DEVELOPMENT APPLICATION ASSESSMENT REPORT

| Application Number: | DA2022/0912 |

| Land to be developed (Address): | Lot 14 DP 223810, 13 Coora Avenue BELROSE NSW 2085 |
| Proposed Development: | Construction of a dwelling house |

Figure 1: SE building envelope breach

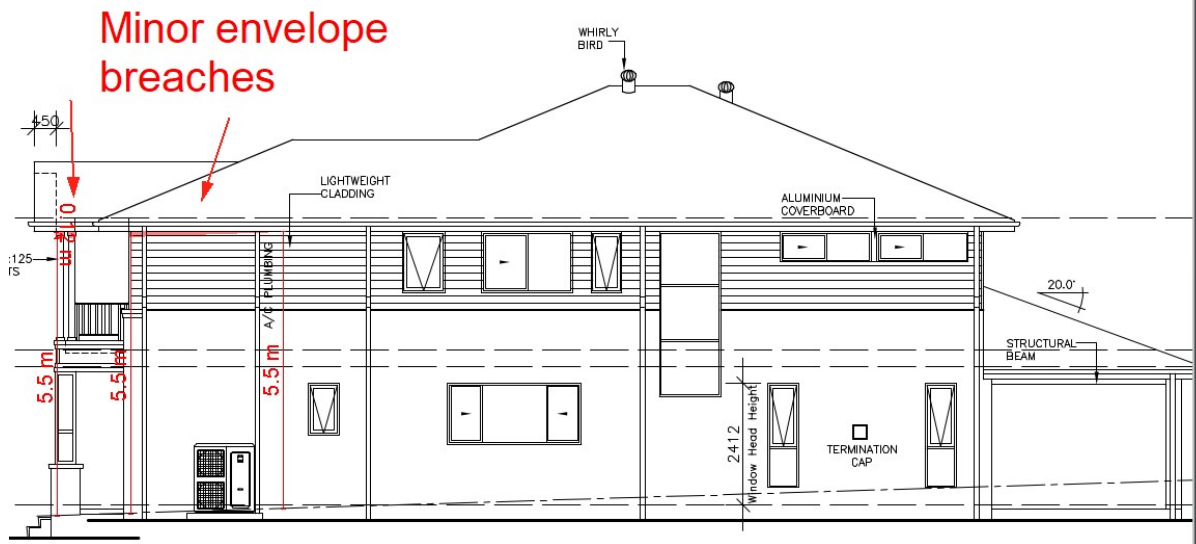
The proposed dwelling house includes a small variation to the side building envelope provision on the south-eastern elevation. The extent of the non-compliance represents a 2.18% variation to the numeric requirement and is confined to a small portion of the wall plane and posts for the covered front balcony on the first floor. Figure 1 below depicts the extent of the variation.

The proposed development complies with the height of buildings development standard and Warringah DCP 2011 wall height provision applicable to the site, thereby demonstrating an acceptable height for the site. In addition, the proposal is two storeys in height, which is commensurate with the scale of surrounding development. Compliant side setbacks and stepped upper floors have also been provided to mitigate the visual bulk as perceived from adjacent properties. For these reasons, it is considered that the proposed development will not become visually dominant by virtue of its height and bulk.

The Warringah DCP 2011 solar access provision requires at least 50% of the required private open space on the subject site and adjoining properties (i.e. 30sqm of private open space) to receive 3 hours of solar access between 9am - 3pm on June 21 (winter solstice). The shadow diagrams submitted with this application indicate that these areas will receive the required amount of solar access. Furthermore, larger window openings on the south-eastern elevation of the first floor adjoin low use areas (i.e. stairwell, WIR and ensuite), whilst the south-eastern facing windows adjacent to the second living space on the first floor contain 1.77m high window sills, which will ensure that adequate visual privacy is maintained to the adjacent property at 15 Coora Avenue (south-eastern adjacent site). The boundary fencing is also sufficient to prevent overlooking from the ground floor windows. Overall, the proposal will allow for adequate solar access and privacy to be maintained to the adjacent property to the south-east, notwithstanding the numeric non-compliance to the side building envelope provision.

The roof form reduces in height with the slope of the land, which falls from the east to the west. Therefore, it is considered that the development responds to the topography of the site.

Having regard to the above assessment, it is concluded that the objectives of the control have been achieved. Therefore, the application is supported on merit in this particular circumstance.
